Sundry Notices and Reports on Wells

JICARILLA 117 E #1

UNIT N SECTION 33, T-26-N, R-3-W
FRUITLAND COAL RECOMPLETION

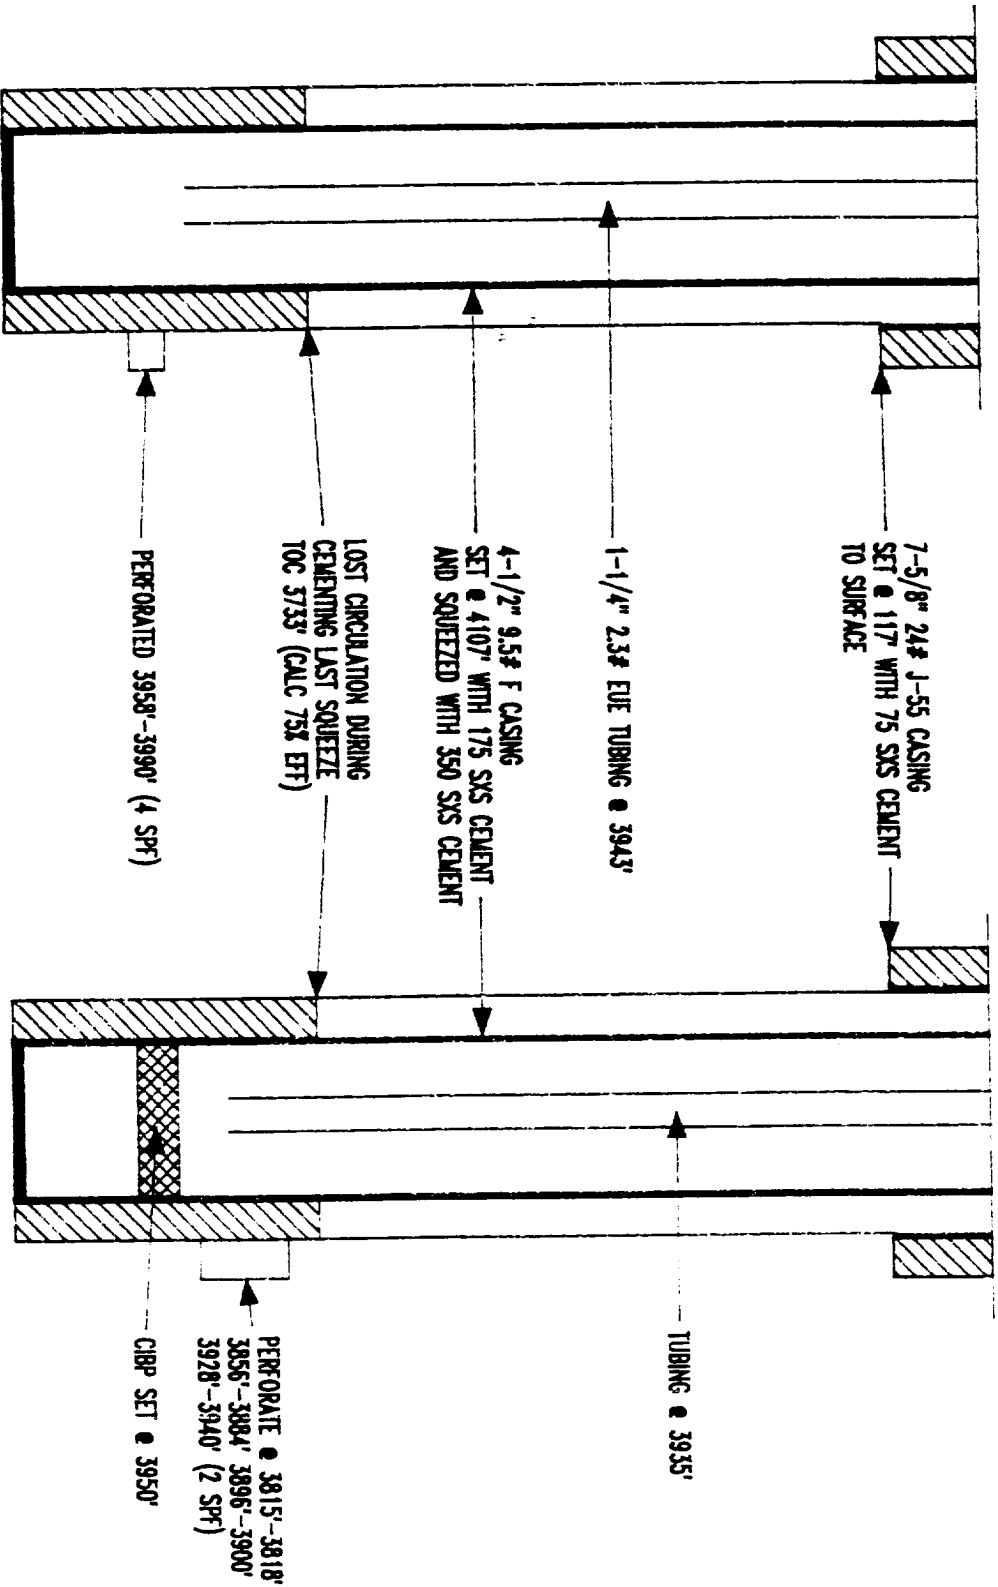
Set 4 Cement Retainer @ 3.50 and
squeeze the perforations in the pictured cliffs.
